SERVICE BULLETIN

PURPOSE : CHANGE	ISSUE NO. : MSB-15EXML42-001	DATE : 2015-09-30
SUBJECT : Addition of the caution statement about the application procedure of the damping sheet on the roof panel		<DESTINATION/MODEL> (As per attached sheet 1) <M/Y> 16
GROUP : Gr:42(Body)		OUTLANDER(GF0W)/ OUTLANDER PHEV(GG0W)

ABE00604AB

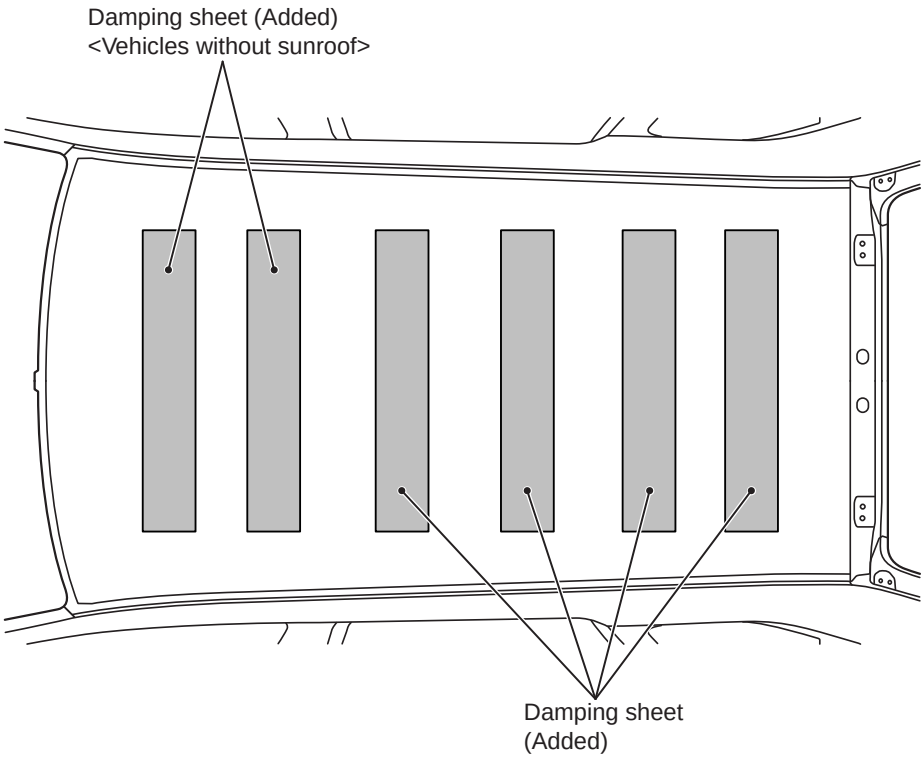
<Added>

⚠ CAUTION

Be careful not to apply excessive load to the roof panel, otherwise it may be deformed.

In order to adhere the damping sheet to the roof panel securely, apply a load of 19.6 N (2 kgf) or more evenly to the whole surface of the sheet (except the bead) back and forth at least once with a roller*.

*NOTE: *: The width of the roller is not specified.*

ABE00577AB

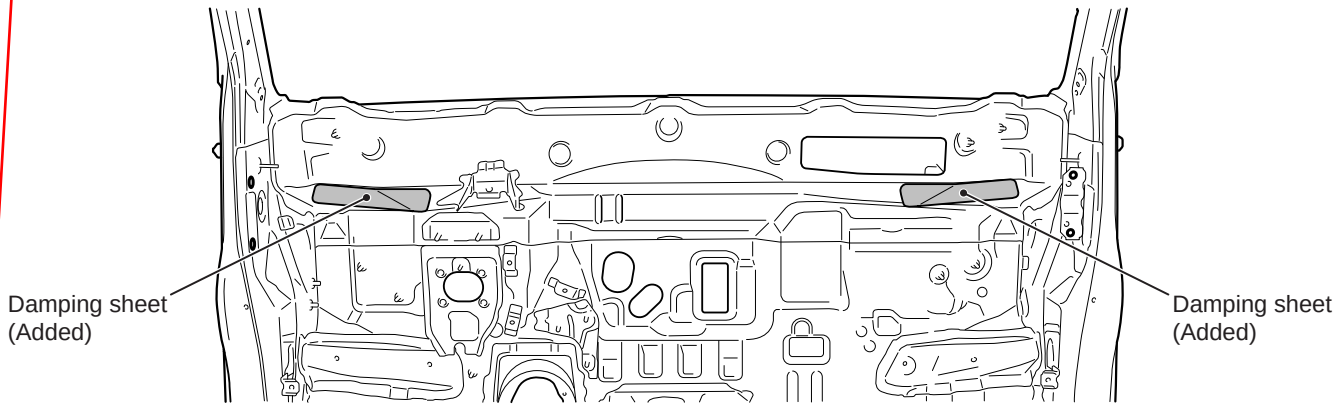
<Added>

⚠ CAUTION

Be careful not to apply excessive load to the roof panel, otherwise it may be deformed.

In order to adhere the damping sheet to the roof panel securely, apply a load of 19.6 N (2 kgf) or more evenly to the whole surface of the sheet (except the bead) back and forth at least once with a roller*.

*NOTE: *: The width of the roller is not specified.*
